Existing Building Investigation & Evaluation Report

Prescriptive Compliance Method

123 Main Street
Anytown, MA 00001

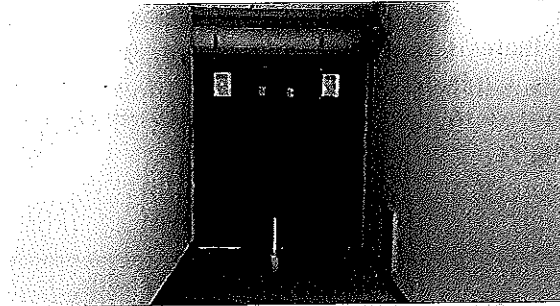
Assessment: Currently, there are six (6) points of entry and exit from the building. Some conditions do not comply with current or previous code editions as illustrated below. However, means of egress patterns, exit and entry doors will be totally reconfigured in conformance with 780 CMR, Ninth Edition, to accommodate the new *Bulk Storage Merchandising Building* use requirements. Construction documents for the renovation project will establish new means of egress patterns.

No Exit Signage
